GCCN Submission

BusConnects Galway: Dublin Road

February 2023

Traffic Lights and Pedestrian Crossings

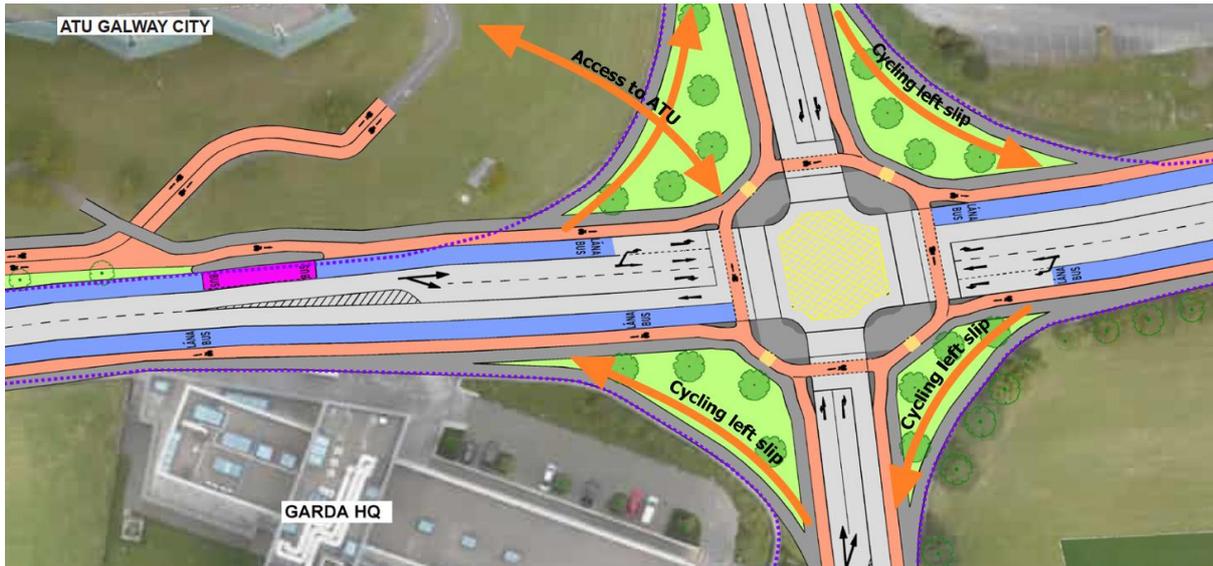
There is valid concern that in Galway pedestrian crossings are often more about managing people on foot for the benefit of traffic than facilitating walking. The recent Kirwan junction rearrangements are viewed as having removed time from people on foot and on bicycles in order to facilitate cars. Significant delays have been imposed on people who walk or cycle. People must have enough time to cross the road particularly at locations where younger or older people are trying to cross.

GCCN expresses concern about the location of push buttons on pedestrian and toucan crossings at other locations in the city. The poles should not be so close to the edge of the main roadway that people waiting to cross are in an exposed position. Where push buttons are intended for bicycle users, they should be accessible to people using cargo bikes. The turning radius at junctions and traffic signals with cycling facilities should be feasible for cargo bikes.

The Junction of R338 Dublin Road and Renmore Road

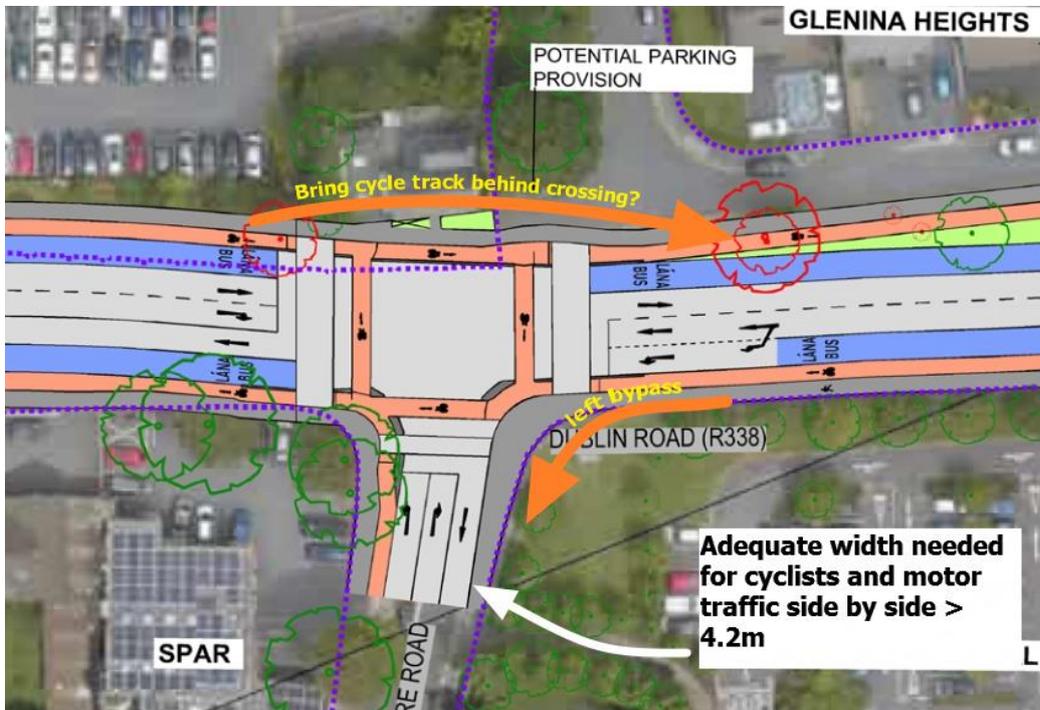
GCCN proposes that the house facing Duggan's shop on northside of the junction of junction of R338 Dublin Road and Renmore Road should be given a dedicated parking/driveway arrangement within Glenina heights. Consideration should be given to swapping the footway and cycle track through the junction on the northside, so the cycle track by-passes the junction and pedestrian crossings. Alternatively, the cycle traffic on the crossing arm should have a green signal even when main arms are red, unless there are people on foot using the crossing. Adequate width is needed for cyclists entering Renmore Road from the R338. The junction arrangements should also allow cyclists to bypass the lights to turn left unless there are people on foot using the crossings. Renmore Road is a route to two schools. Adequate width is needed on the entry to Renmore Road so that cyclists do not get squeezed by motor traffic.

Belmont junction

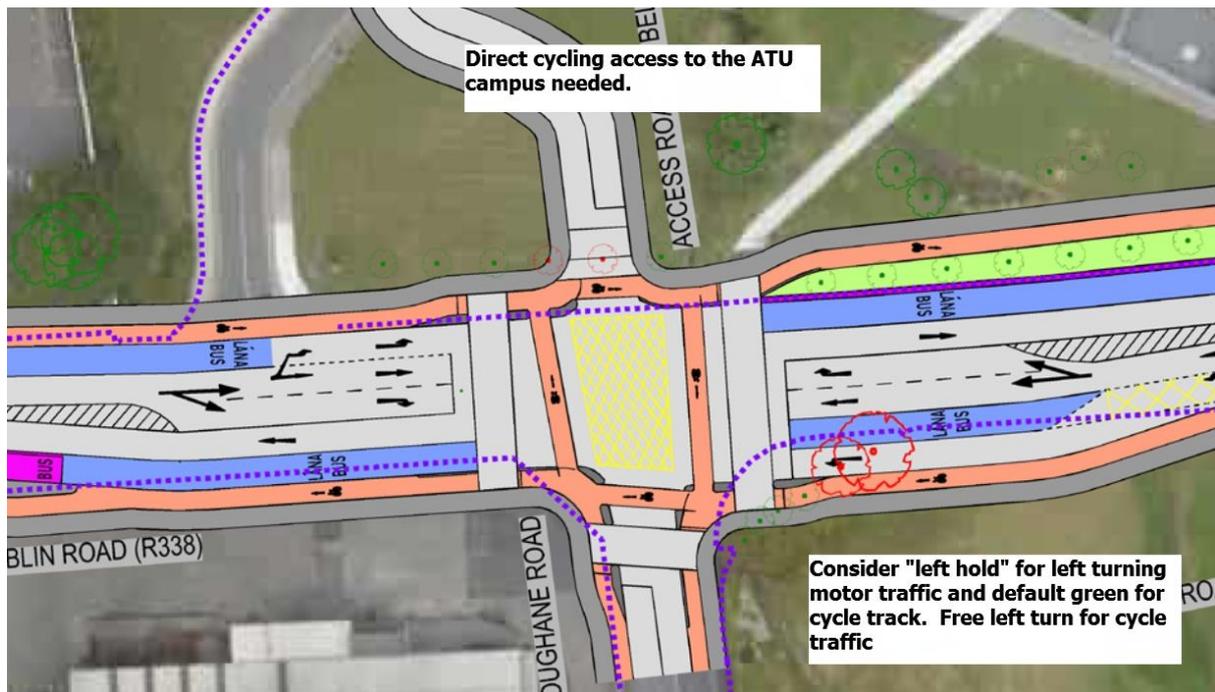
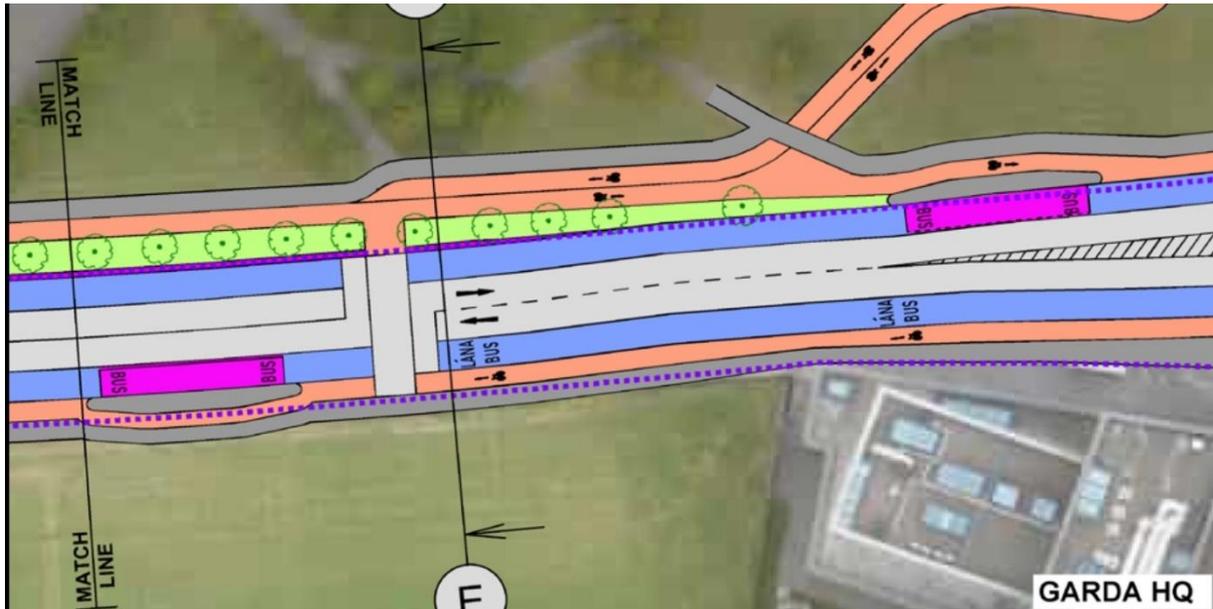
Consideration should be given to making the Belmont junction into a Cyclops layout with a direct link into the ATU campus. On the westbound arm consideration should be given to a hold-the-left arrangement on the R338 with a default green for westbound cycle traffic. Consideration should be given to making the eastbound arm flashing amber for motor traffic turning into Belmont.

Galway Crystal Junction:

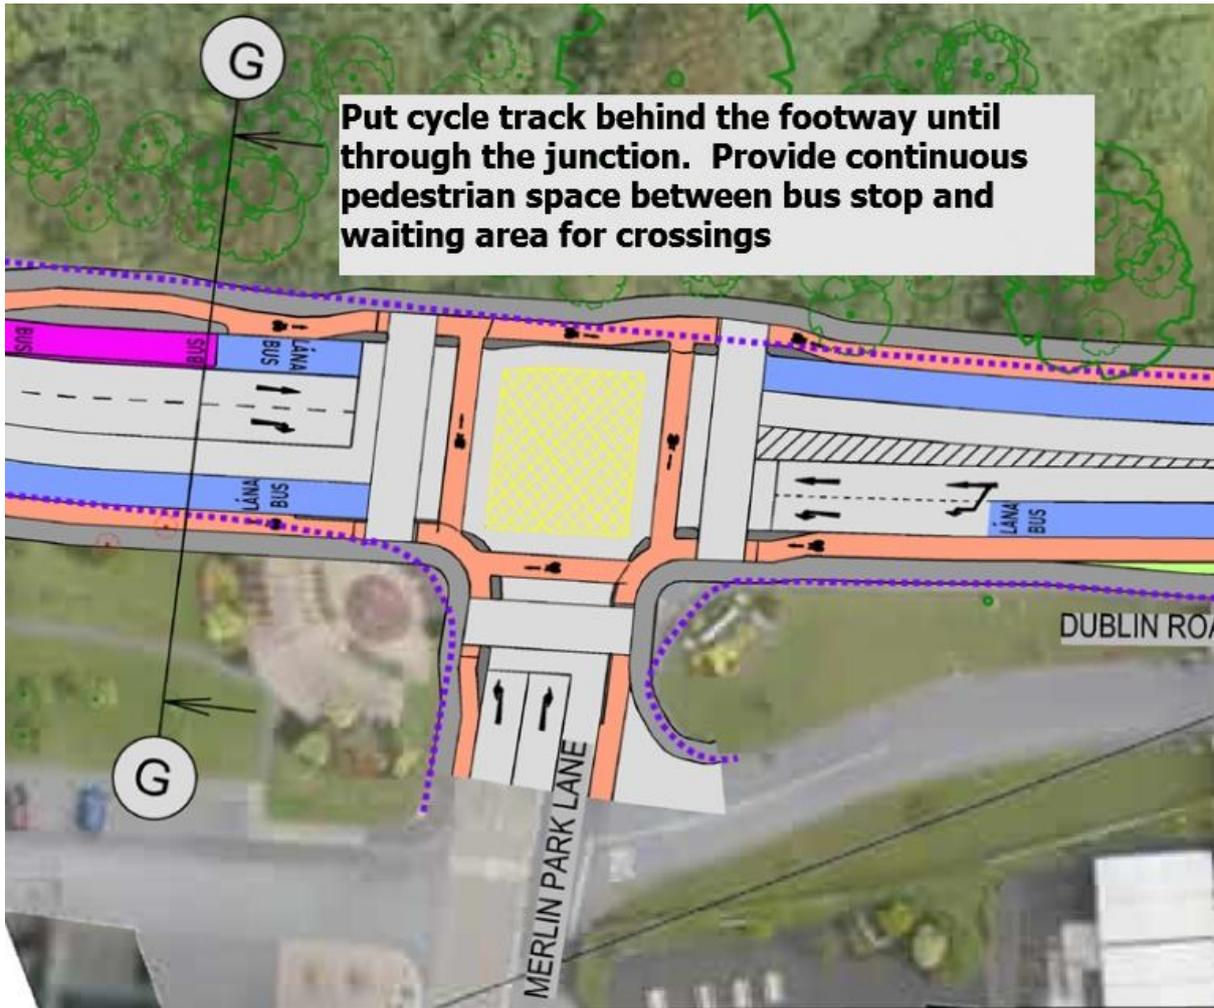
GCCN requests that consideration is given to the conversion of this junction to a Cyclops Junction.

Observation: The floating bus stop/island should be continued to, and through, the traffic lights. This means that the cycle track will be on the left of the pedestrian space at the junction. This will remove conflict with the eastbound cycle traffic who will be able to keep moving regardless of the traffic signals or pedestrian crossing state

The connection along the boundary of Galway Crystal through to Rosshill road should be formalised and upgraded. This is the natural desire line for cyclists coming from, or to, the coast road or Rosshill itself.
